Denial

Subject: Mine Ventilation Plan, Section 75.370, 30 CFR, Upper Big Branch Mine-South, I.D. No. 46-08436, Performance Coal Company, Montcoal, Raleigh County, West Virginia

Ventilation Plan

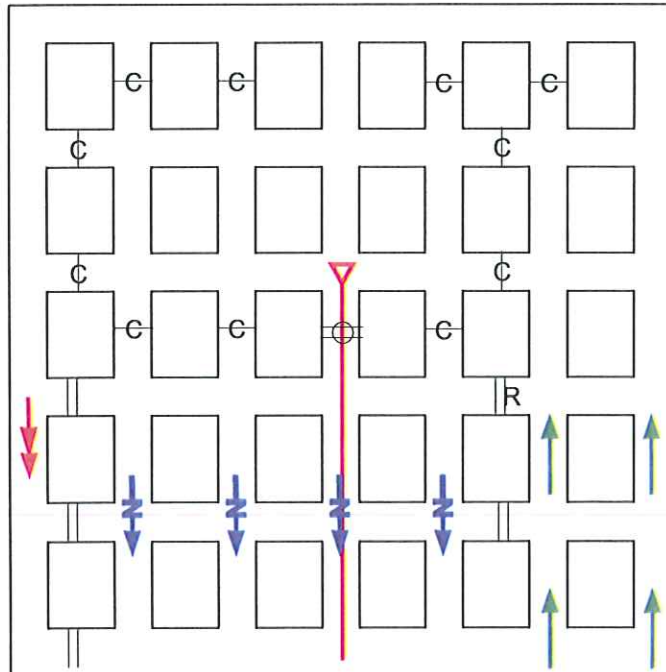
Need address

Distance & Spacing of c/o monitors

Address Belt Air

Need to Address the BARRIER Block between the sealed Area & Tailgate entries of the Northern District Bleeder System

Need FACE SKETCHES & NARRATIVE PORTIONS for longwall Development & Retreat mining, Drive DIAGRAM, ETC.

External Bleeder System Utilizing Barriers
For Initial Pillar Section (Drawing 1)
VENTILATION BASE PLAN

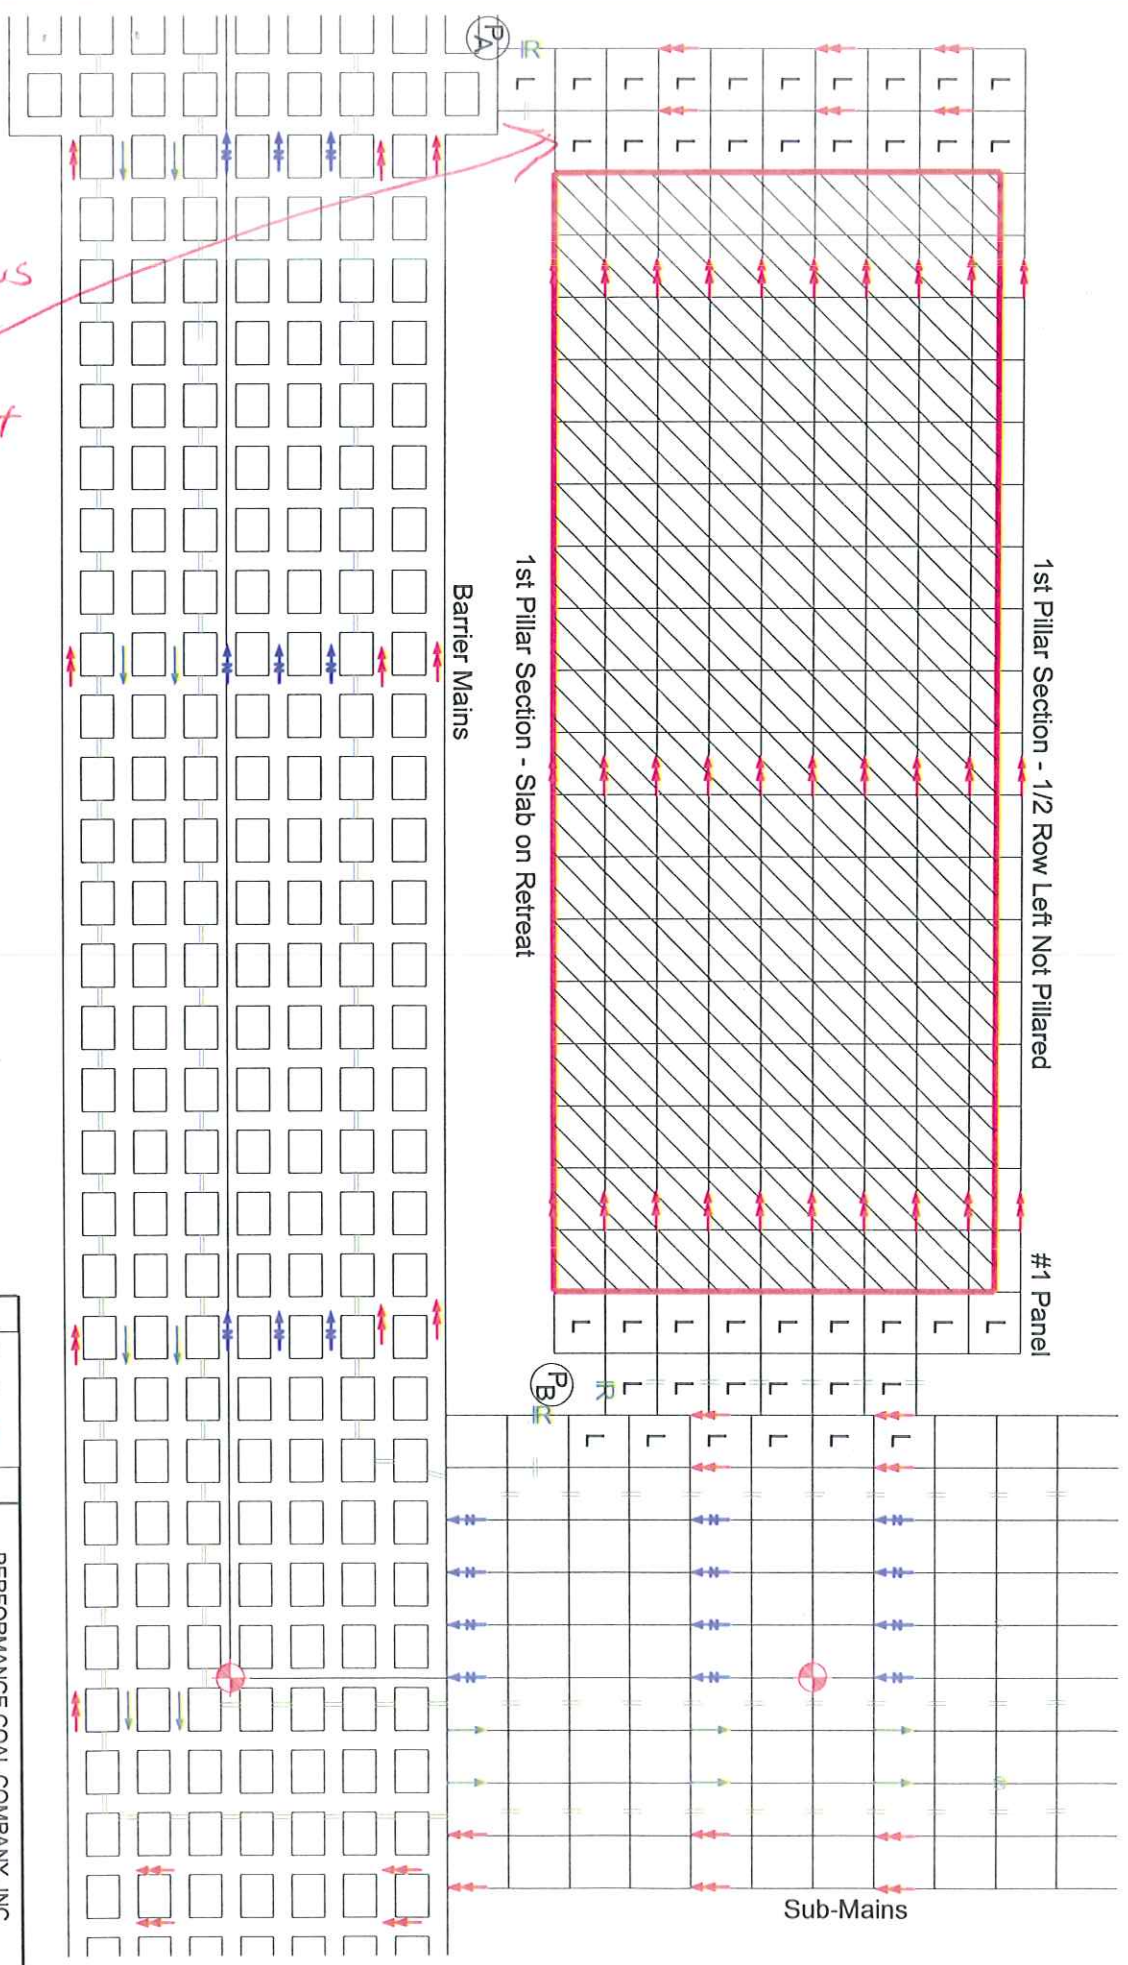
- *Two safe Travelways will be maintained To the Bleeder Evaluation Check Point*
- *WATER will not be allowed TO Accumulate And block or obstruct bleeder Flow*

*Drawing 3
Shows 3 Rows
on Back of
Panels. All
Sketches must
match*

External Bleeder System Utilizing Barriers
To Pillar Multiple Sections (Drawing 2)

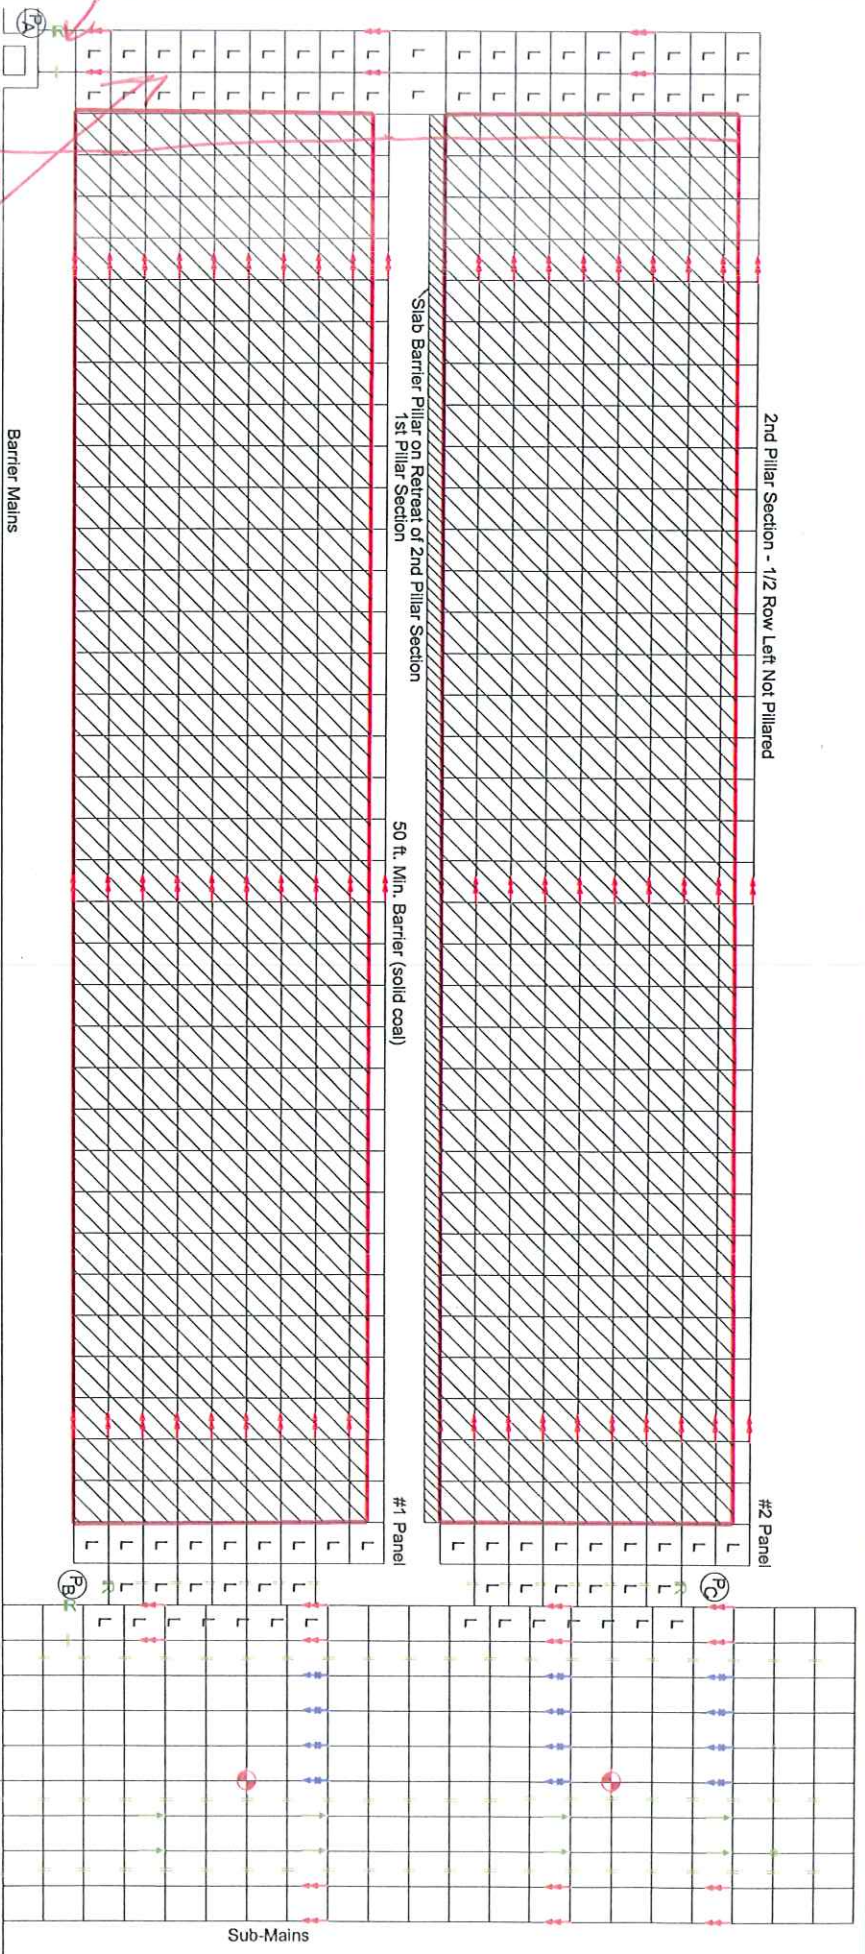
Remove

Two SAFE Travelways will be maintained to the bleeder EVALUATION Check Points

Water will not be allowed to Accumulate and block or obstruct bleeder flow

Show Controls
+BP Across
back of each
Panel

Drawing 3
Shows 3 Rows
on back of Panels
All Drawing
must match

REMOVE

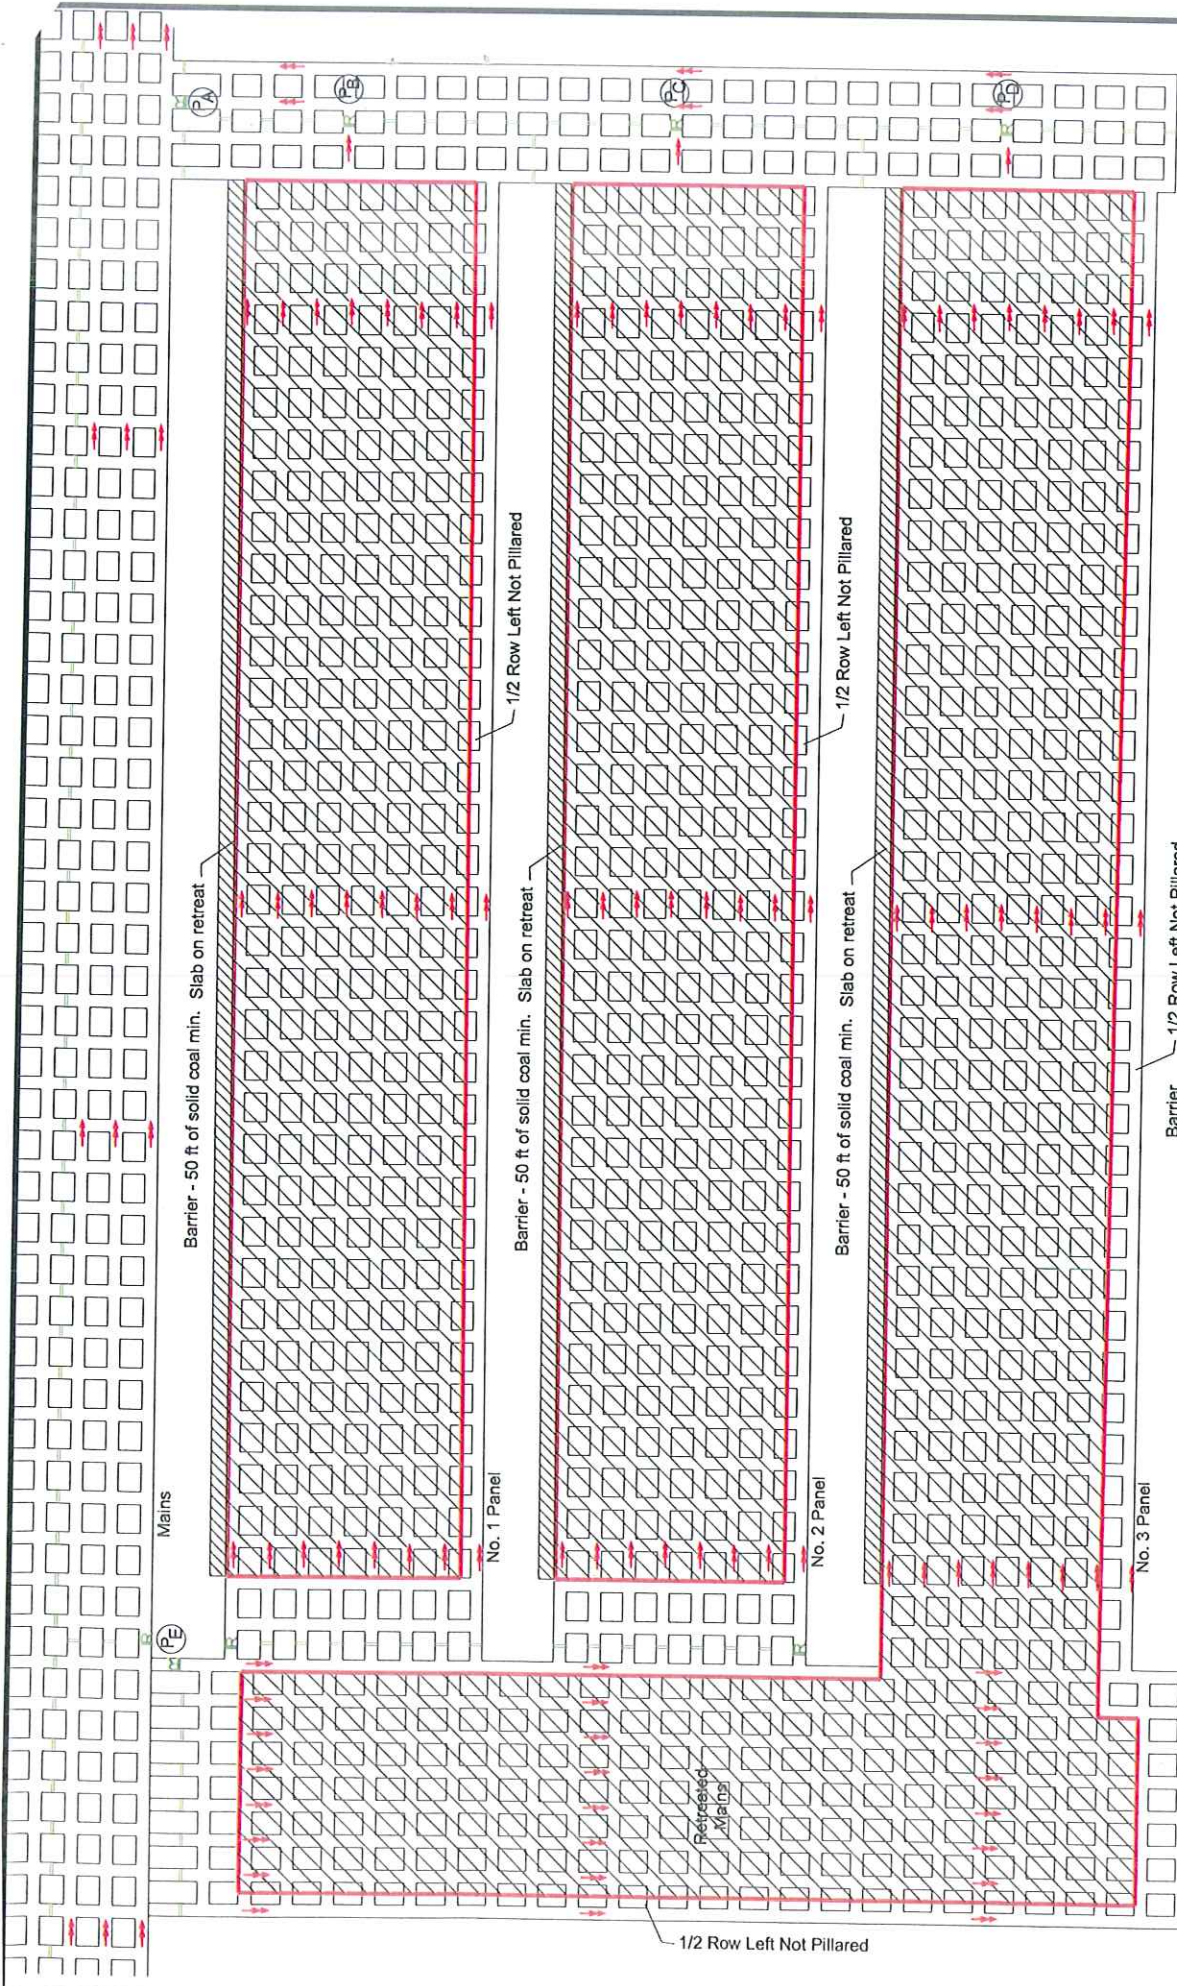
- *Two safe TRAVELWAYS will be maintained To the bleeder Evaluation Check Points*
- *WATER will not be allowed TO Accumulate and block or obstruct bleeder Flow*

Internal Bleeder System Utilizing Barriers
For Initial Pillar Section (Drawing 4)

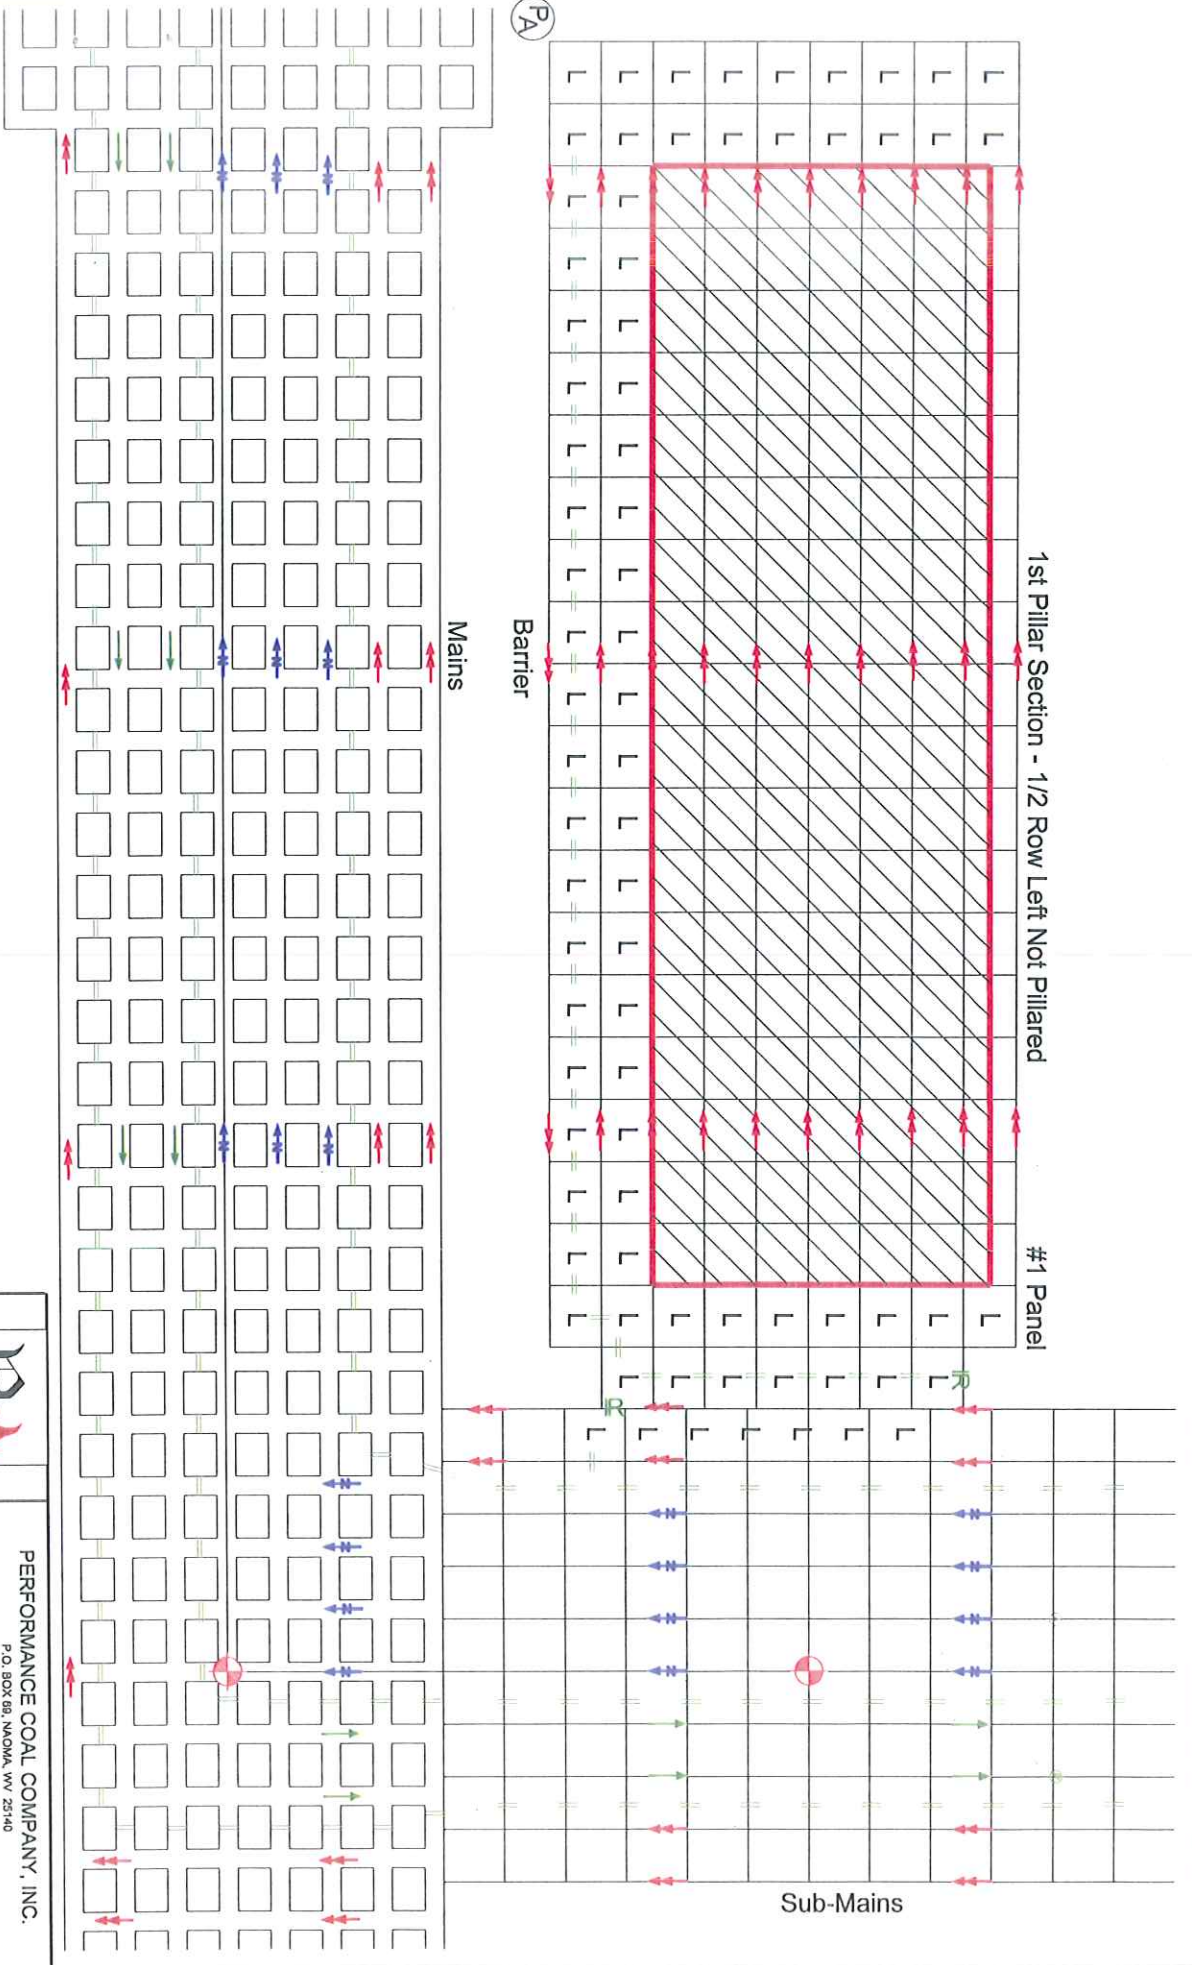
*Two safe Travelways will be maintained to the
bleeder Evaluation Check Points
WATER will not be allowed to Accumulate and
Block or obstruct bleeder Flow*
